Technical Memorandum

Subject 78-90 Beechwood Avenue/ 69-93 Barrette Street - TIA Addendum 1

This technical memorandum has been submitted in response to City's transportation-related comments received on November 19, 2020, regarding the Transportation Impact Assessment (TIA) – Step 4 report for 78-90 Beechwood/ 69-93 Barrette, dated July 30, 2020. The TIA was prepared in support of both a Zoning By-Law Amendment Application as well as Site Plan Control.

Appendix B – Updated Existing (2020)
Traffic Volume Exhibit

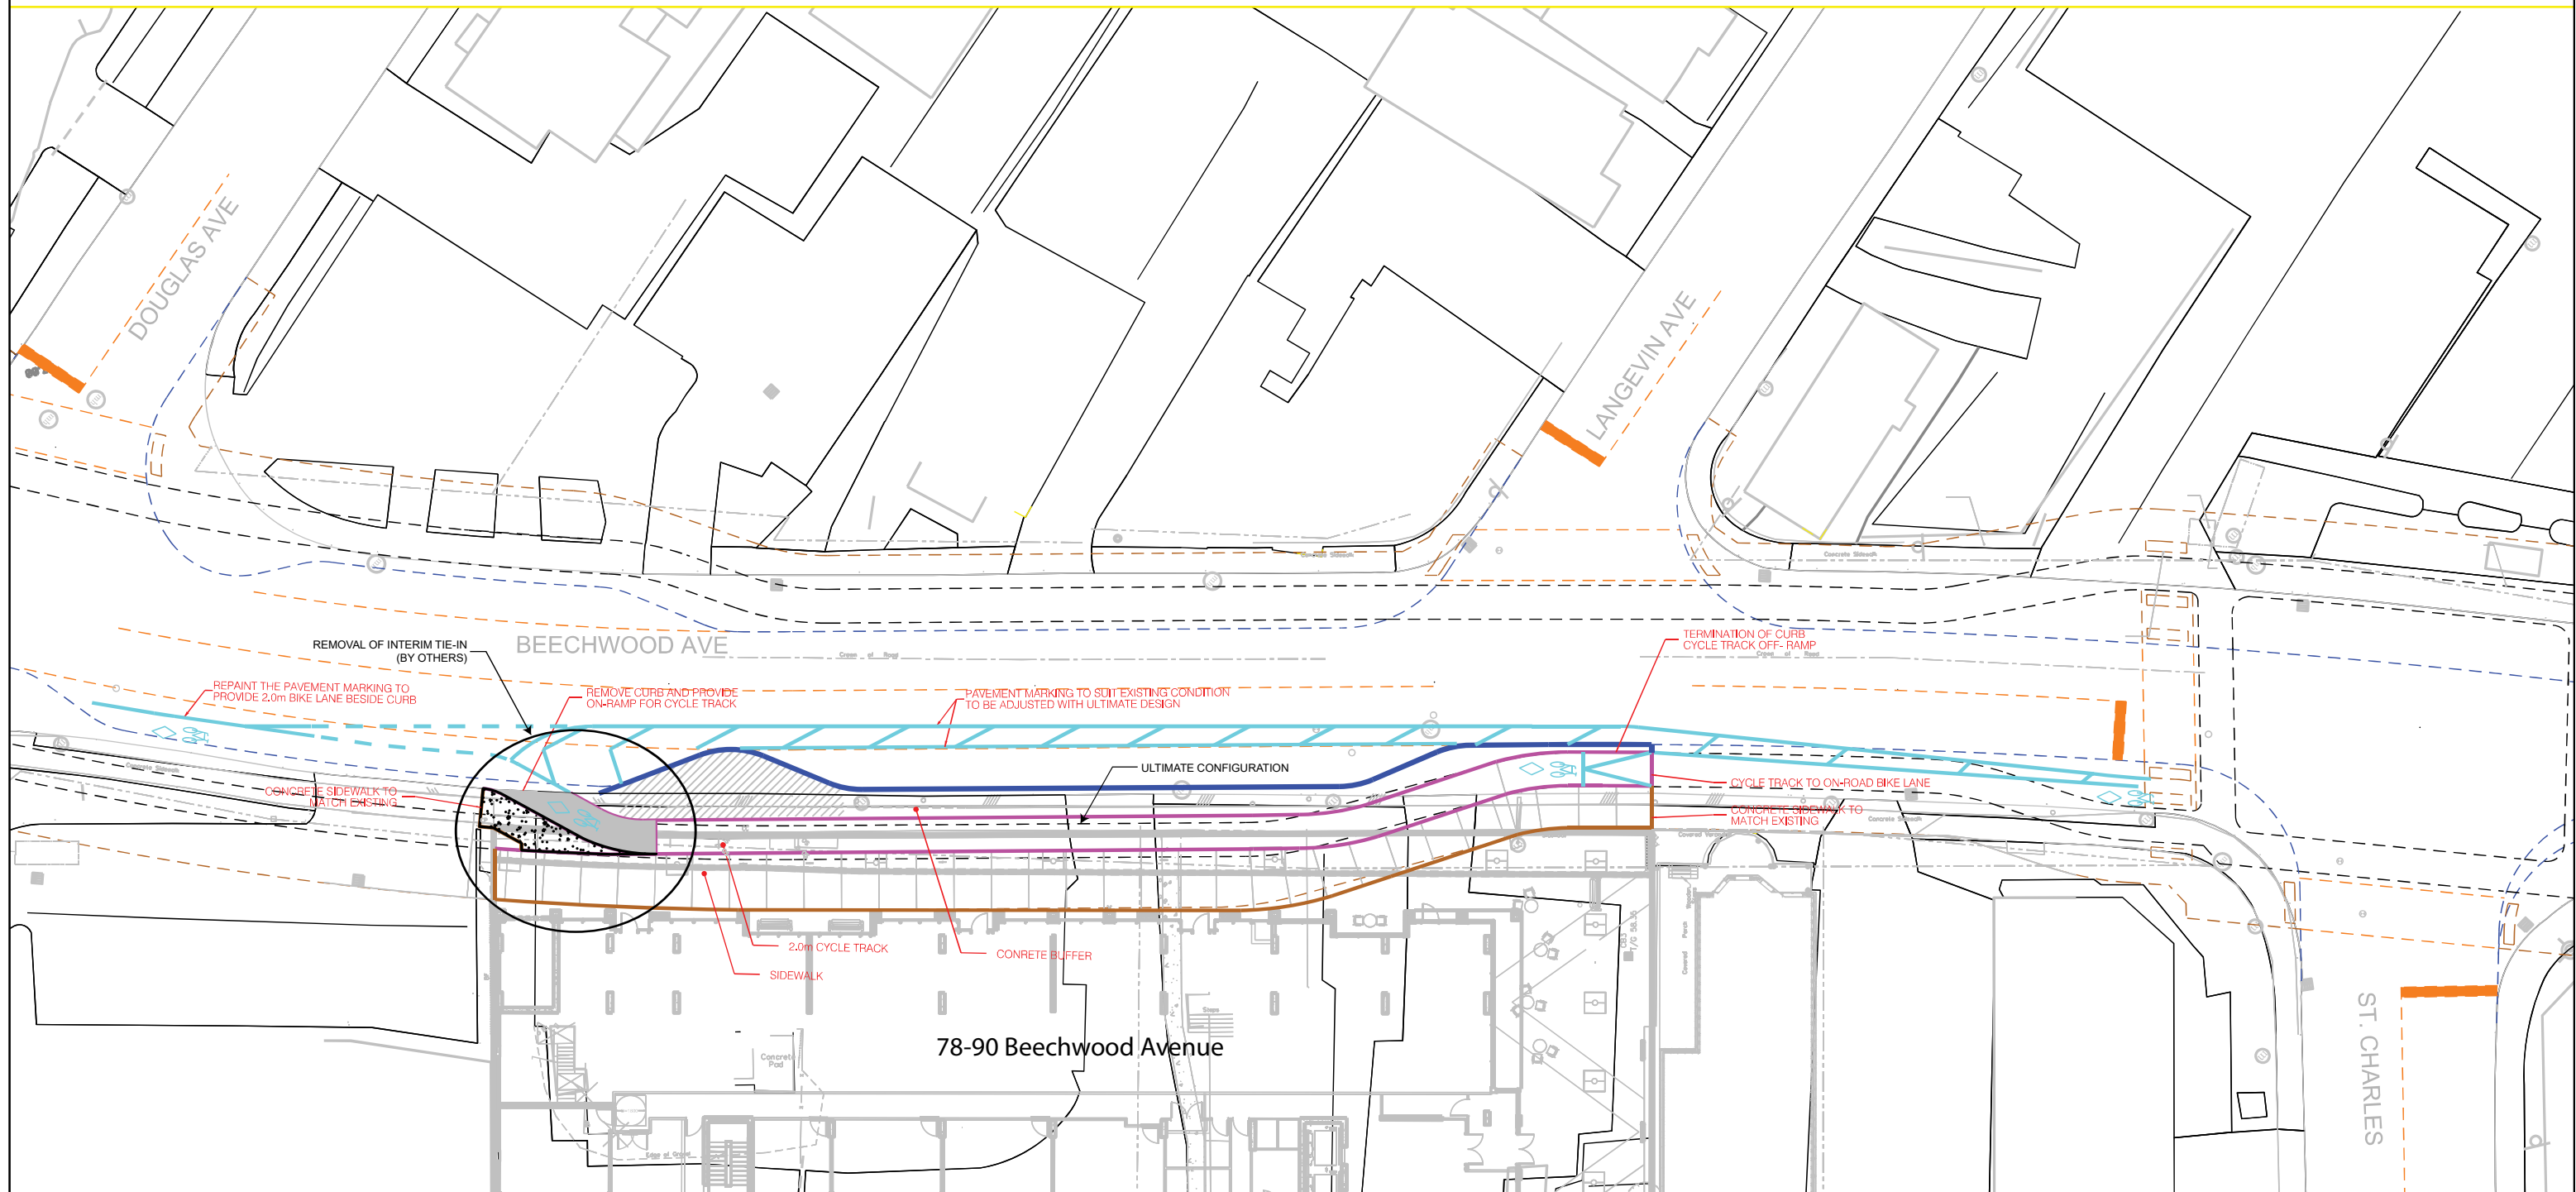
Comment 2.1: The existing conditions traffic data illustrated in Exhibit 4 must include pedestrian and cycling information. Ensure that summer count data is used to determine feasible numbers for these modes.

- **IBI Response: Exhibit 4, as shown in Appendix B, has been updated with pedestrian and cycling volumes, based on turning movement count data purchased from the City of Ottawa. It is acknowledged that active transportation trips may be under-represented in these turning movement counts, which were conducted in the winter months, however this count represents the most recent data available from the City at the time that this TIA was undertaken. The potential under-representation of active transportation trips bears no consequence to the results of the TIA and is shown for information purposes only.**
